Assembly Notice between AIMB- 763 and ACP-2010MB/ACP-2320MB/ACP-4000MB IPC-510MB/IPC-610MB-H/IPC-7143/IPC-7220

Fig.3 1700006917 connect with Keyboard/Mouse connector on motherboard and the KB/USB board on front panel

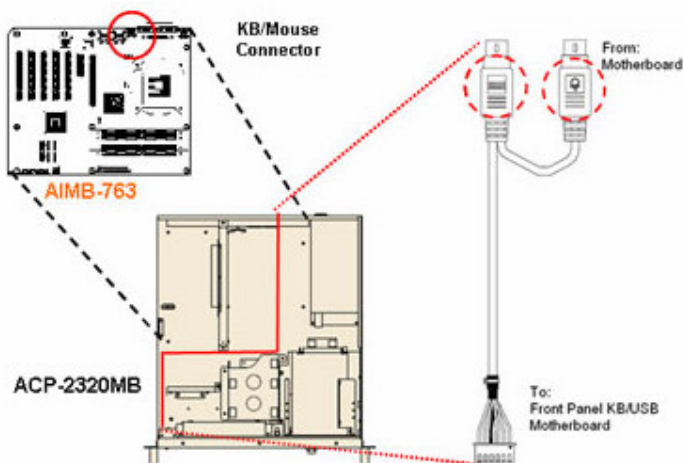
AIMB-763 doesn't provide an external connector for PS/2 port. Front-access PS/2 function of chassis listed above would face a difficulty to enable it.

- (1) If customers need a PS/2 port support in front-panel of chassis above with AIMB-763, kindly refer picture below to enable front PS/2 interface of these chassis.
- (2) Please order an extra cable, 1700006917 to install AIMB-763 and PS/2 module of chassis.

Case III. 1700006917 enables the front PS/2 interface
